<b>Docket Number:</b>	17-IEPR-11
<b>Project Title:</b>	Southern California Energy Reliability
<b>TN #:</b>	217845
<b>Document Title:</b>	CSUN Comment about seismic safety of Aliso Canyon and impact on summer reliability
<b>Description:</b>	N/A
<b>Filer:</b>	System
<b>Organization:</b>	California State University Northridge (CSUN)/Matthew d'Alessio
<b>Submitter Role:</b>	Public Agency
<b>Submission Date:</b>	6/5/2017 1:03:44 PM
<b>Docketed Date:</b>	6/5/2017

**Comment about seismic safety of Aliso Canyon and impact on summer reliability**

RE: Aliso Canyon Comprehensive Safety Review

*Geologic cross section through the Santa Susana mountains by Dibblee (1992)<sup>1</sup> overlain on a Google Earth perspective view.*

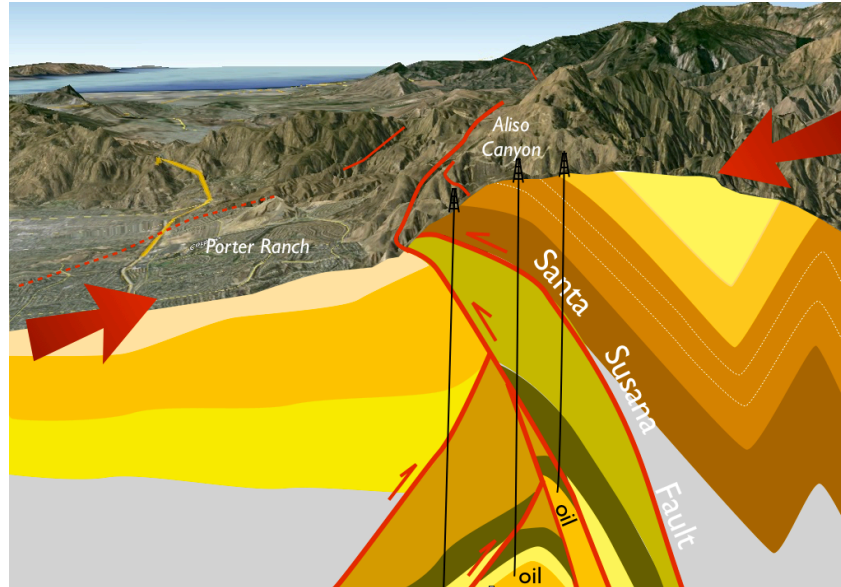
The Aliso Canyon gas storage facility is located directly above the Santa Susana fault and associated structures. The state recognizes this fault as active and has designated an Alquist-Priolo special study zone around the fault. The state maps have a note that the precise surface expression has not been officially investigated in the area of Aliso Canyon. However, we can see evidence of numerous subsurface fault crossings in the mud logs of the oil and gas wells drilled at Aliso Canyon. The wells cross the north strand of the Santa Susana fault around 1000 feet, the southern strand around 2500 feet, the Frew fault around 4500 feet, and various other unnamed structures at depth. These faults appear on geologic cross sections specifically because we know of their existence from where the oil and gas wells crossed them. If these wells were houses being built at the surface, the state would mandate a special study and specific mitigation measures. I prepared the attached geologic cross section graphic to illustrate the faults underlying Aliso Canyon.

According to the Uniform California Earthquake Rupture Forecast (UCERF3) developed by the USGS<sup>2</sup>, the Santa Susana fault is capable of producing a M7 earthquake, and we know that the eastern section of the fault ruptured in 1971, terminating just east of the Aliso Canyon field. We currently have no information about the last rupture of the section beneath Aliso Canyon. Based on standard models<sup>3</sup>, the average slip along the Santa Susana fault will be approximately three feet in size during the next large earthquake and could easily be twice that amount in certain locations.
